**Addendum No. 001**

**Subject:** Rhawnhurst Elementary School- Additions and Renovations  
SDP Contracts No. B-070 (R), B-071 (R), B-072 (R) and B-073 (R) of 2019/20

**Location:** Rhanwhurst Elementary School  
7809 Castor Avenue  
Philadelphia, Pennsylvania 19152

**This Addendum dated December 14, 2021, shall modify and become part of the Contract Documents for the work of this project. Any items not mentioned herein, or affected by, shall be performed strictly in accordance with the original documents, unless modified by prior addenda.**

E INTERIOR ELEVATION E  
1/4" = 1'-0"

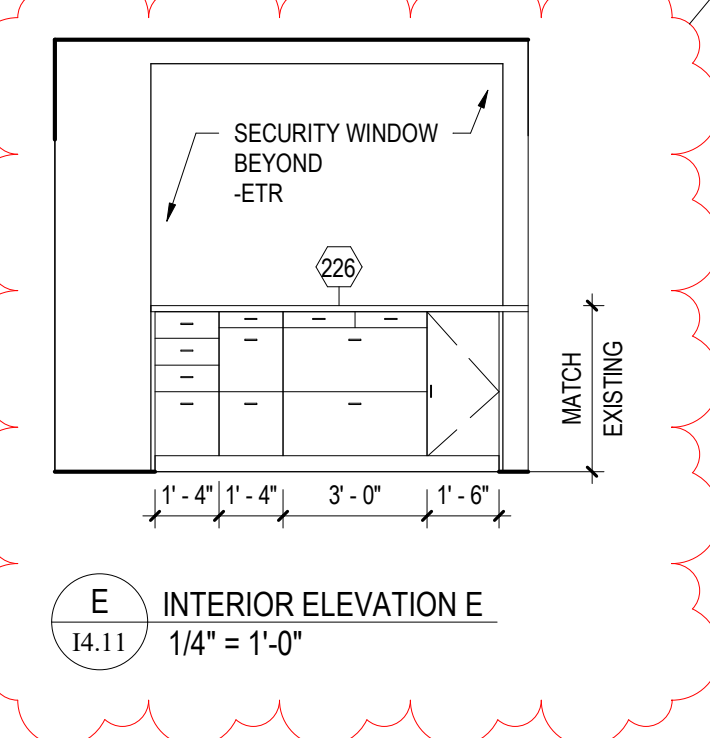
### **DRAWING I4.11 LARGE SCALE LAYOUTS ADMINISTRATION**

1. **ADD** detail E/I4.11 Reception Counter elevation & item no. 226 to the casework & equipment schedule.
